PO Change Order Request Form

Change Order

Project: **McKinley Modular Classroom Building**
McKinley Elementary School
2150 East 14th Street
San Leandro CA 94577

CO #: 3
Date: 7/01/20
Contract Date: December 11, 2019
DSA Application #: 01-118102
DSA File #: 01-35

DRAWING NUMBER:
CCD.011-A0.7

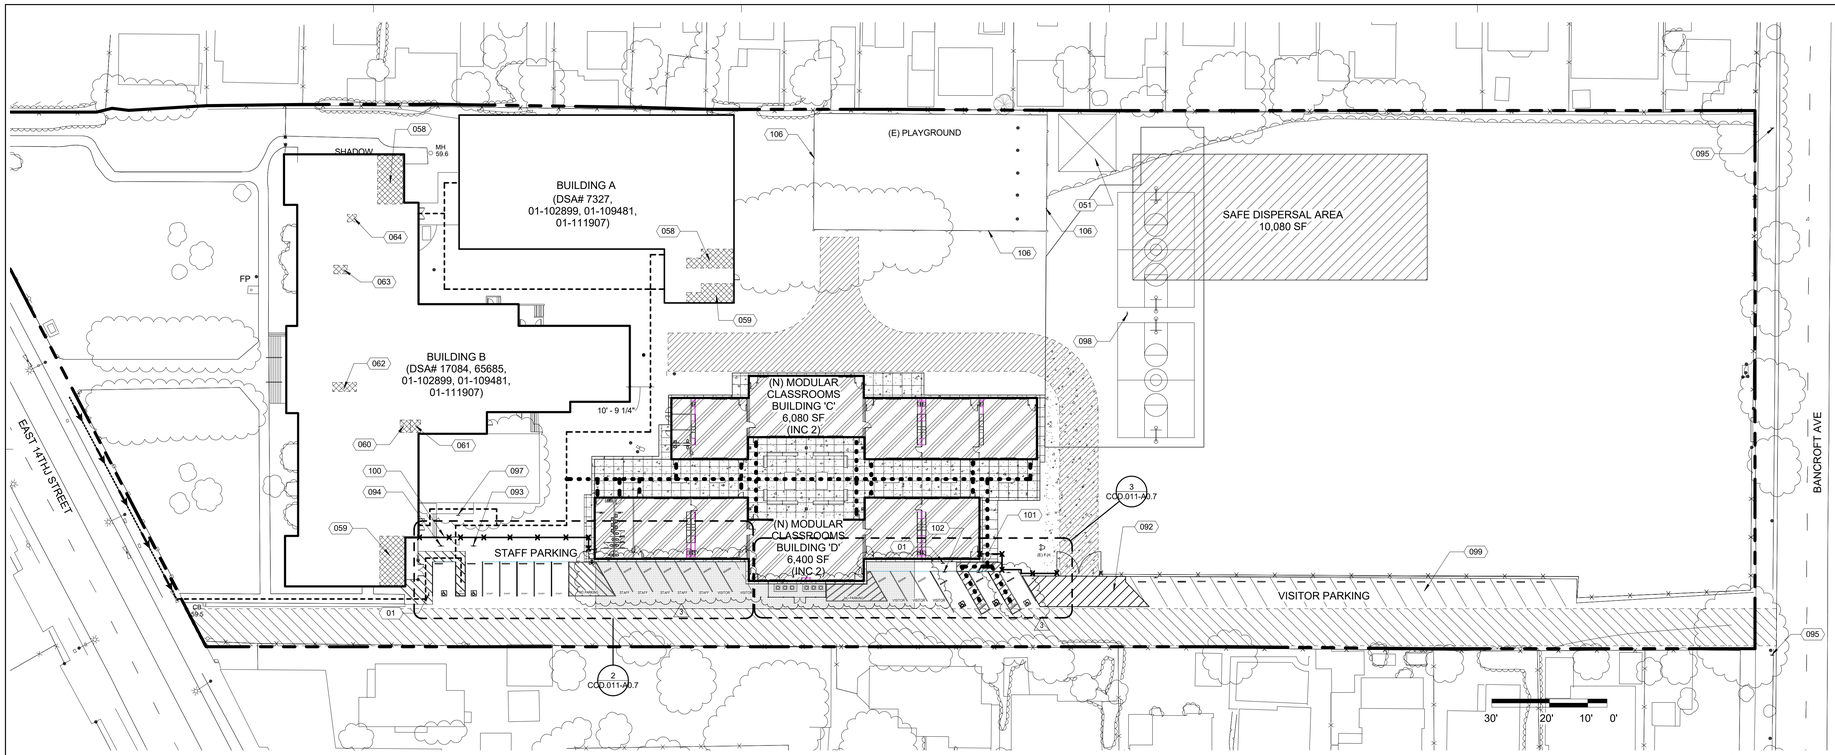
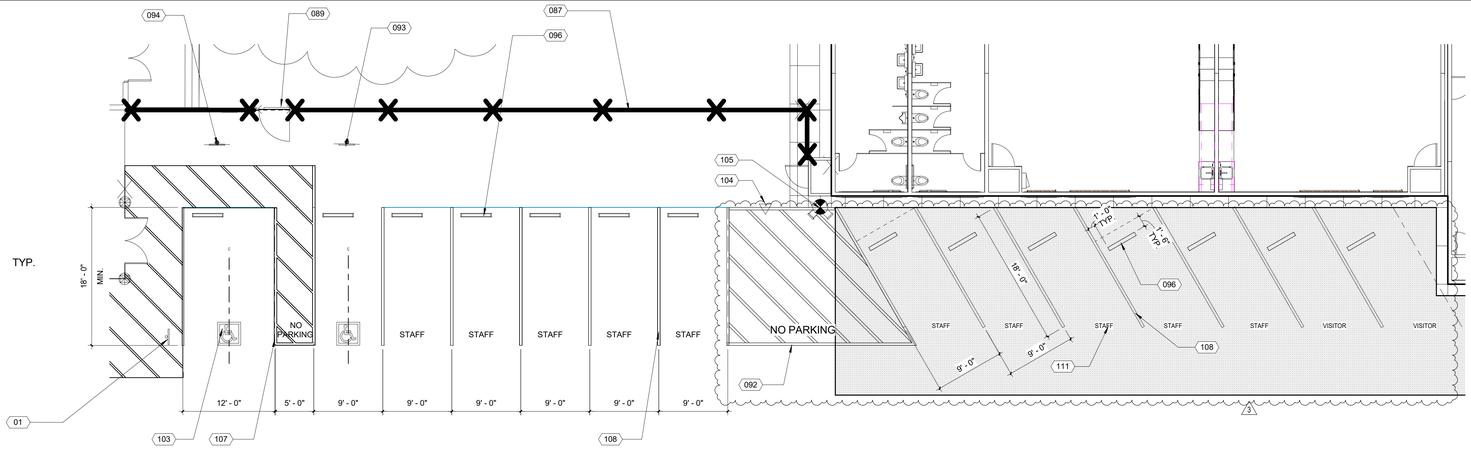
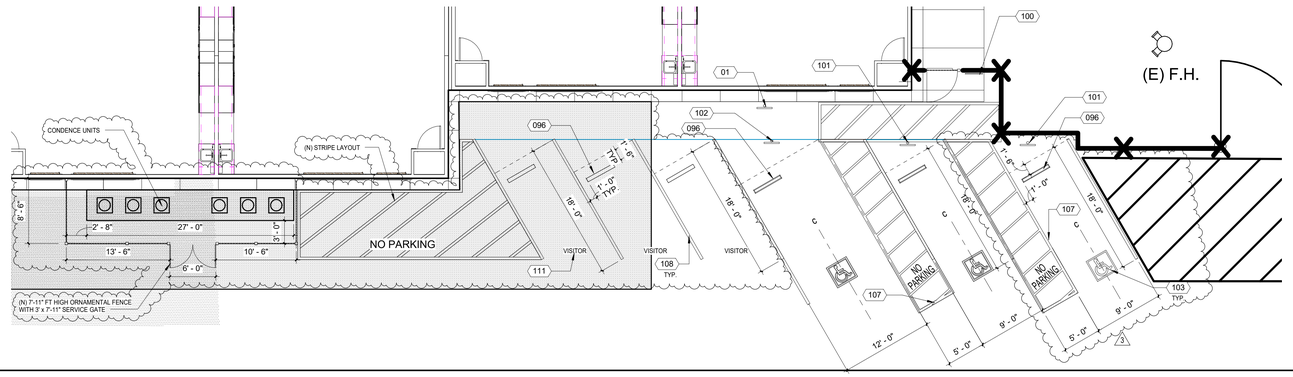
Provide and install additional parking stalls, deleting the specified decomposed granite paving to asphalt concrete paving. Work includes but no limited to HVAC condenser's concrete pad at the new location with ornamental fencing, concrete wheel stop, ADA accessible parking sign, ISA pavement sign, paint striping and pavement marking as noted in the attached drawings CCD.011-A0.7, CCD.011-A1.2, CCD.011-10.1, CCD.011-C3.0, CCD.011-C4.0, CCD.011-C6.1 with Delta 3 revision bubble.

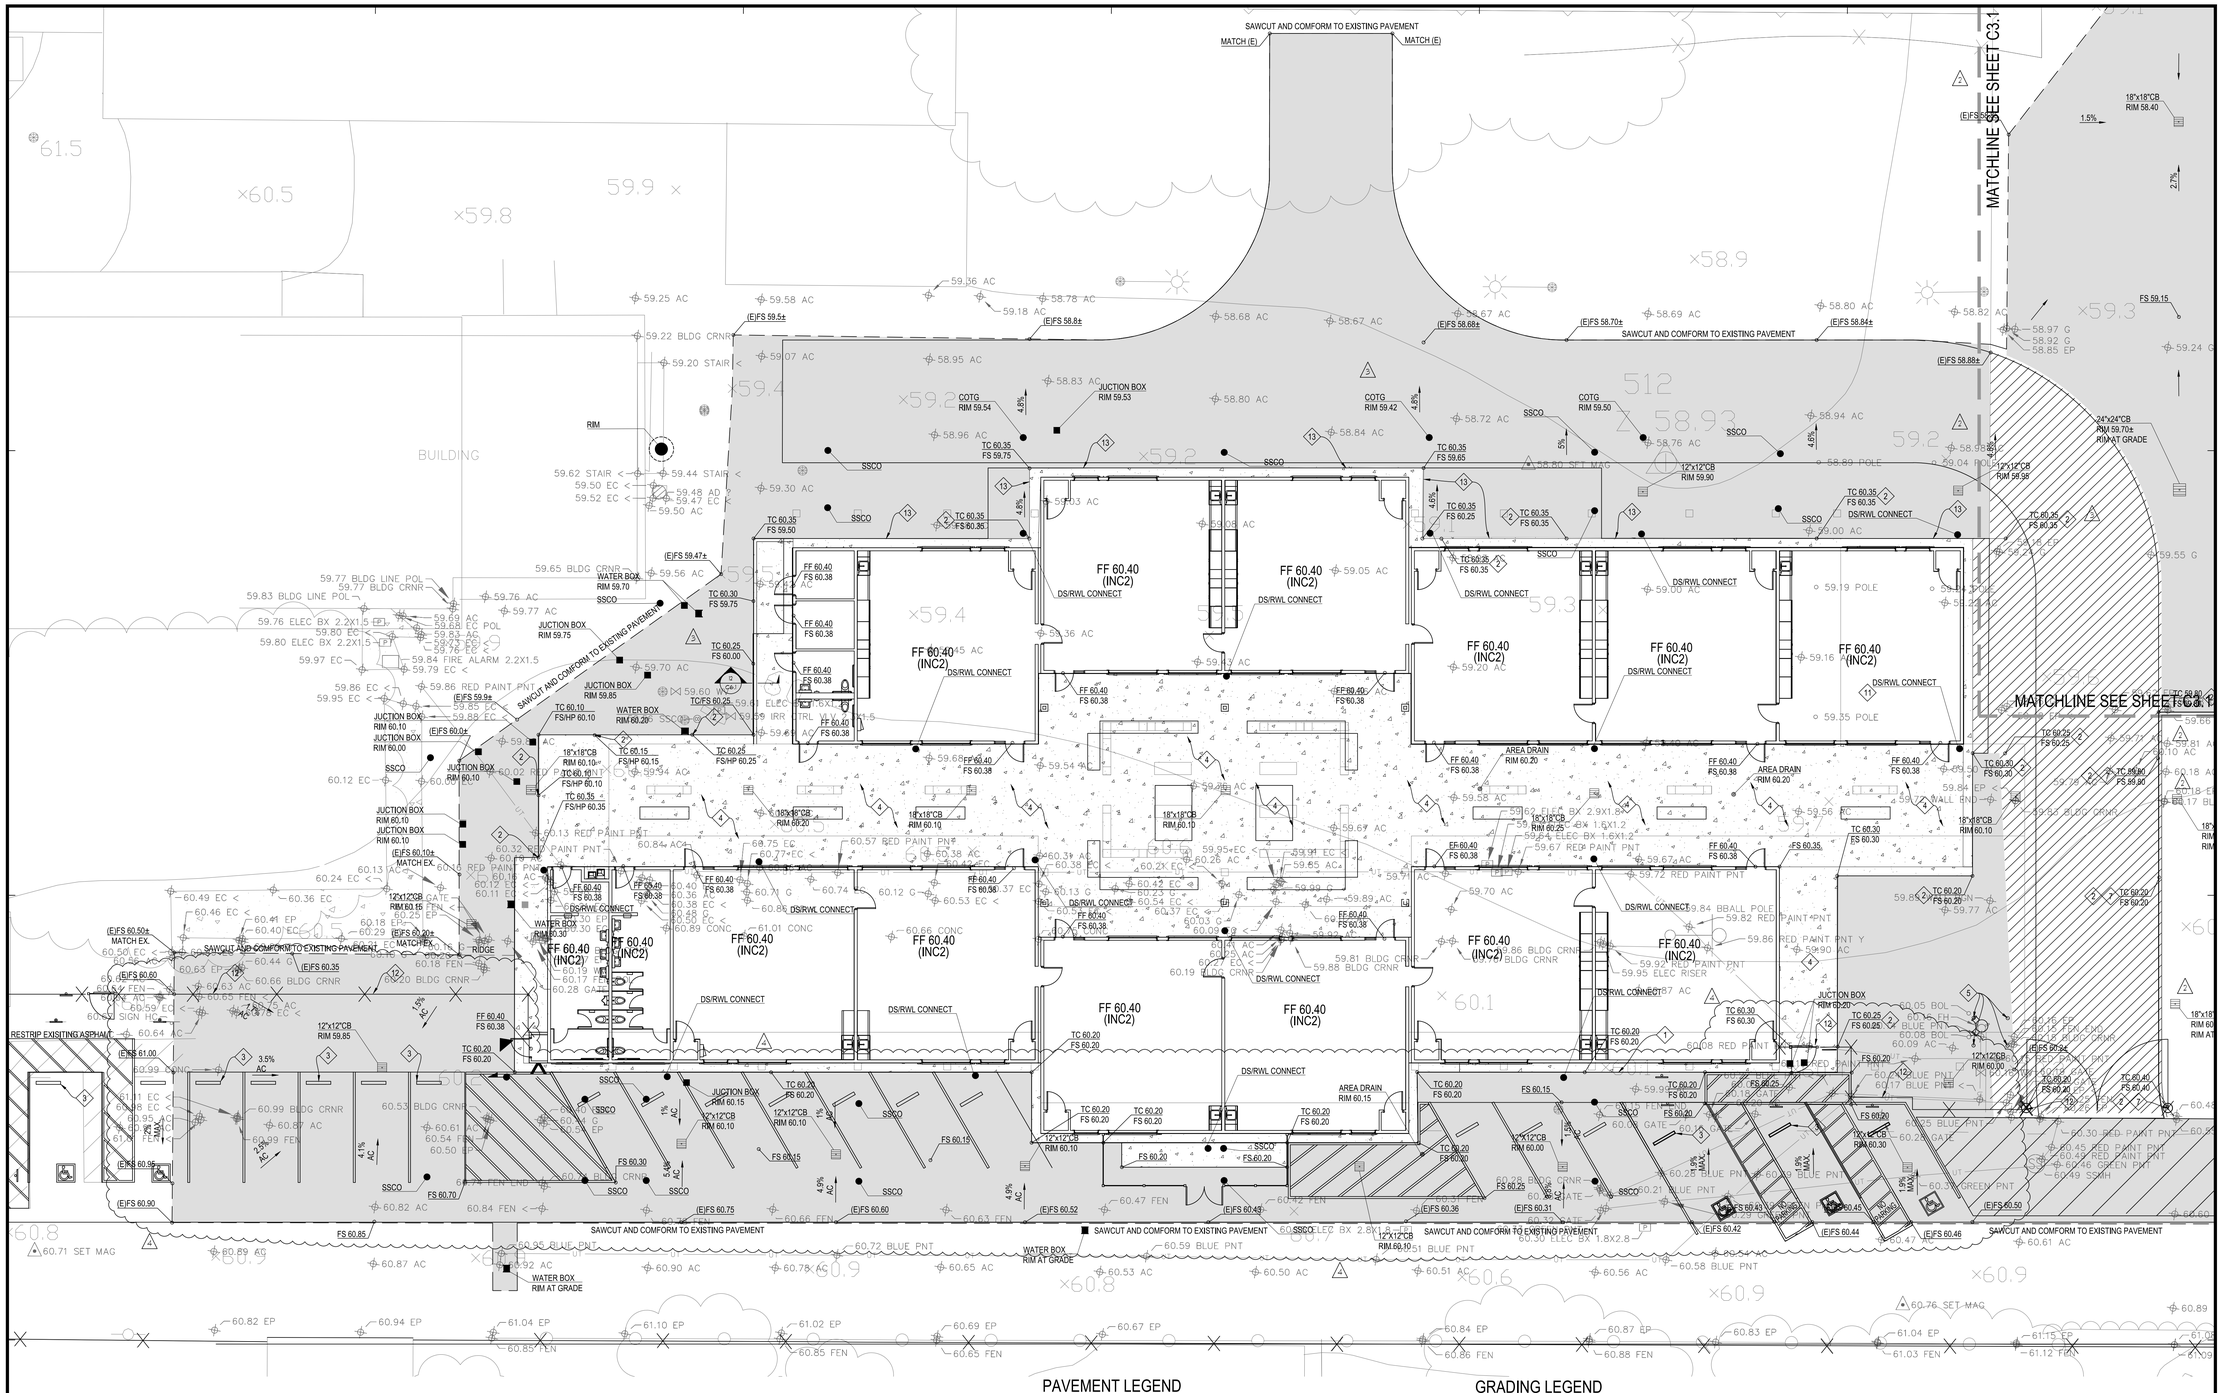
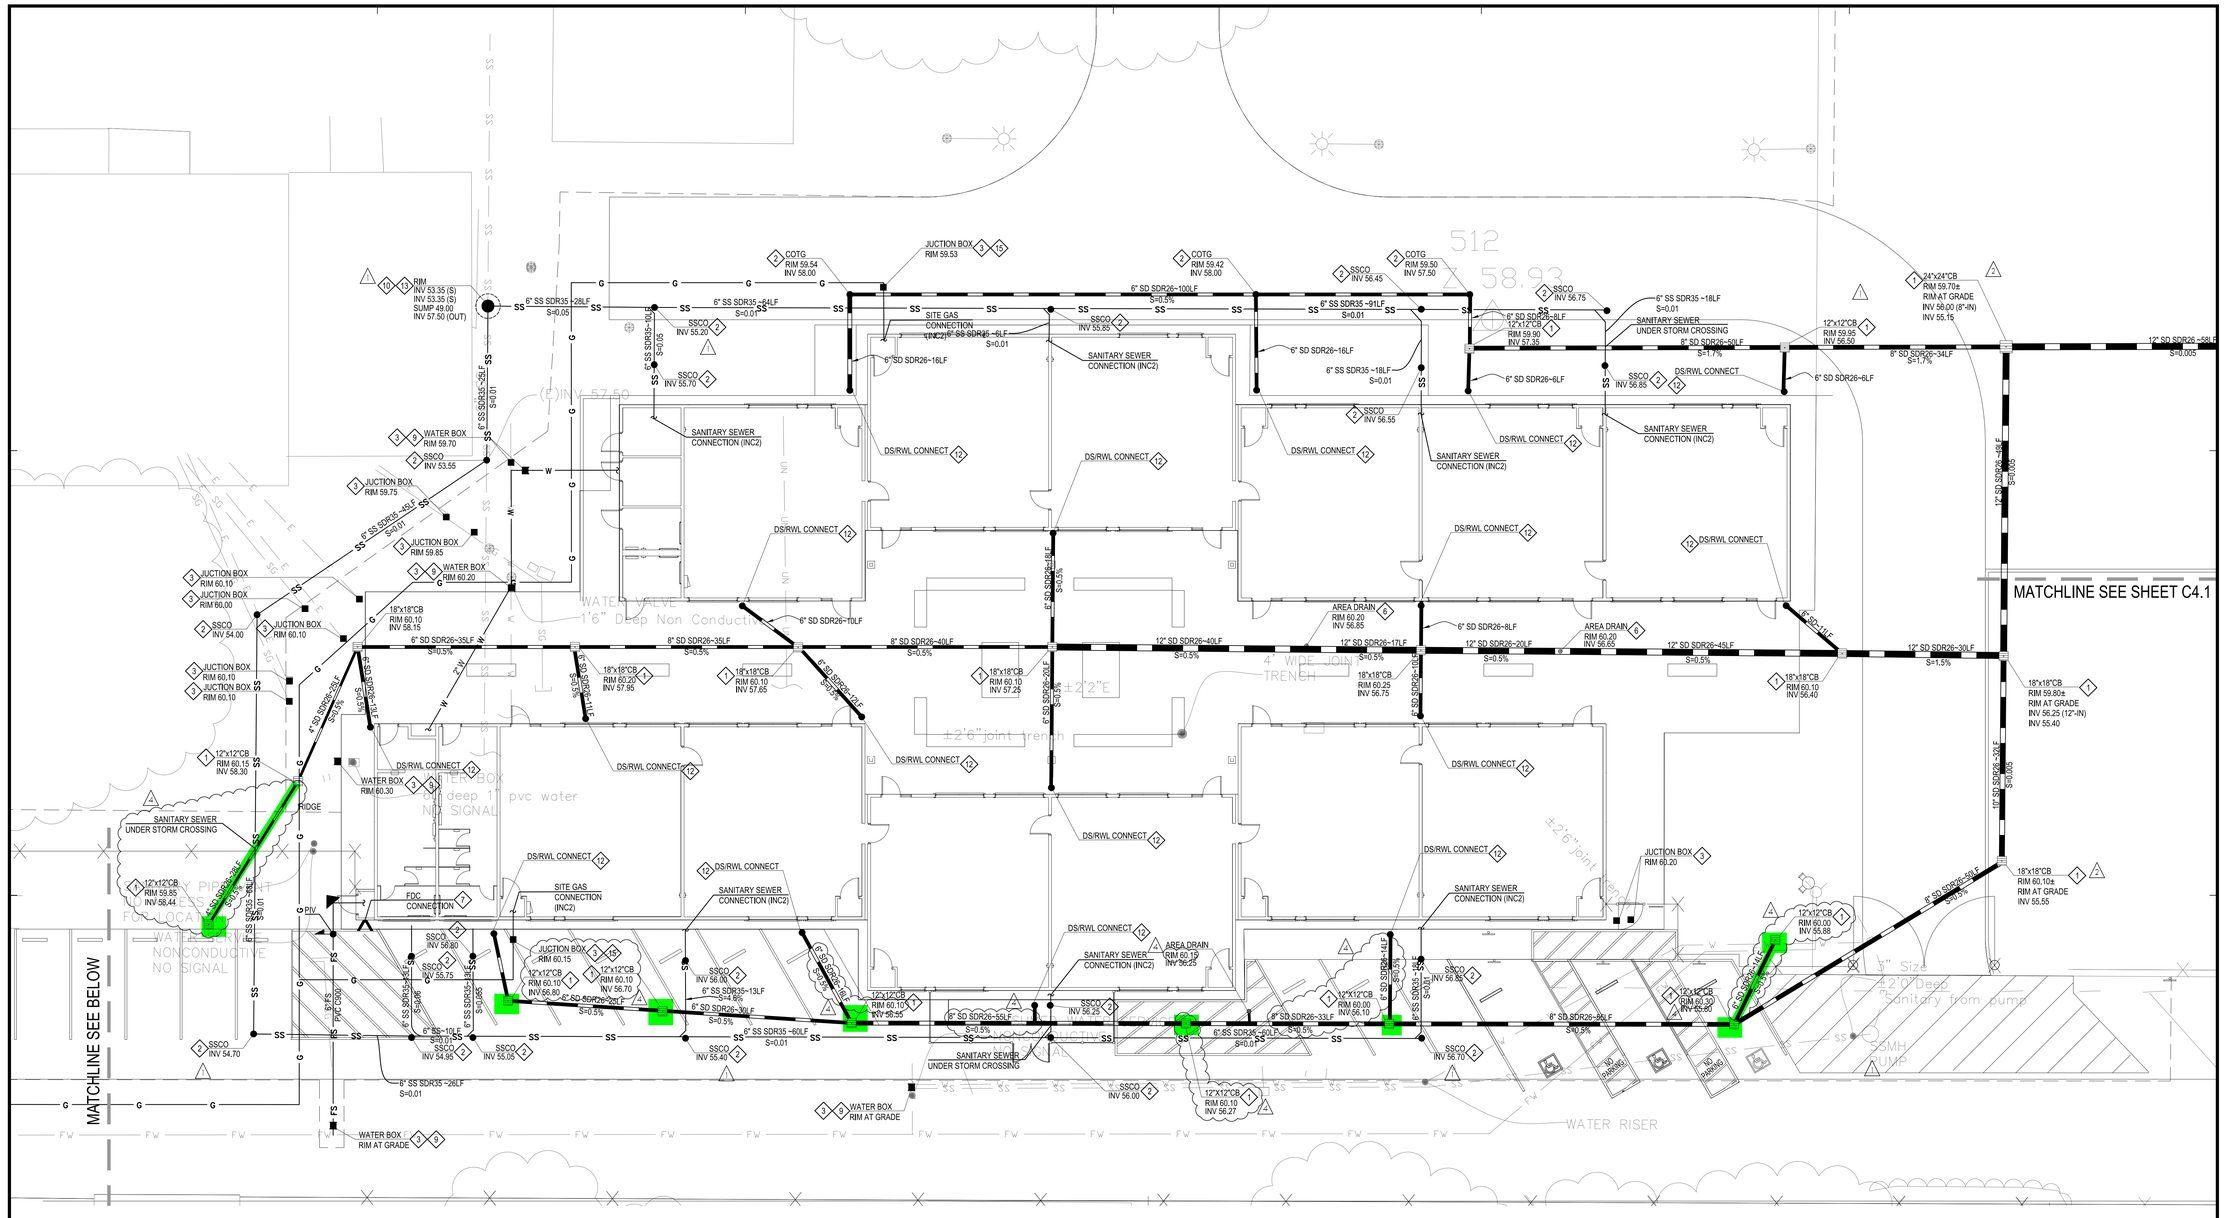
PCO #10 – Added cost to install the additional asphalt and storm drain inlets per CCD #11.

Costs associated with grading and paving scope of work only of south parking lot per CCD #11.

11 ~~TYPICAL CURB & GUTTER~~ **NOT USED**

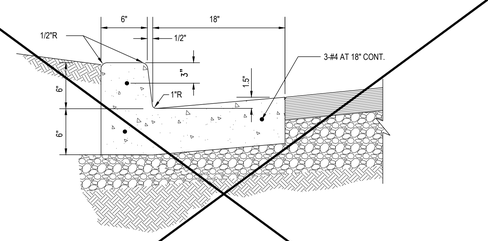
PCO #12 – A credit for the curbs and gutters that were removed per CCD #11.

~~RFI 29: Add 3 Bollards (drill and install bollards supplyed by others: $1,800~~
~~CCD6/RFI142: Delete Mow bands add curb and modify per RFI 142: $2,100~~
~~CCD6: Add footings for 4 Basketball Hoops (sleeves set by others): $5,500~~
CCD 11: Delete curb & Guttter and modify AC Pads: ($8,000)
